MWO 9-1005-319-30-1

## MODIFICATION WORK ORDER

### MODIFICATION OF M16A2 RIFLE

(NSN 1005-01-128-9936)(EIC:4GM)

**10. MODIFICATION PROCEDURES: M16A4 Modification Kit**

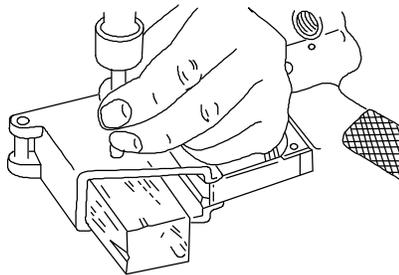
**a.** Stamp the lower receiver to read "M16A4". If the lower receiver must be refinished, this stamping will take place prior to the refinish operation. If refinish is not required, the areas stamped must be touched-up with solid film lubricant. Support the receiver in the stamping area to prevent bending and distortion of the receiver. Overstamp the "2" in M16A2 with an X and to the right of the X, stamp a "4" to read M16AX4, using the same size number stamps as the original number.
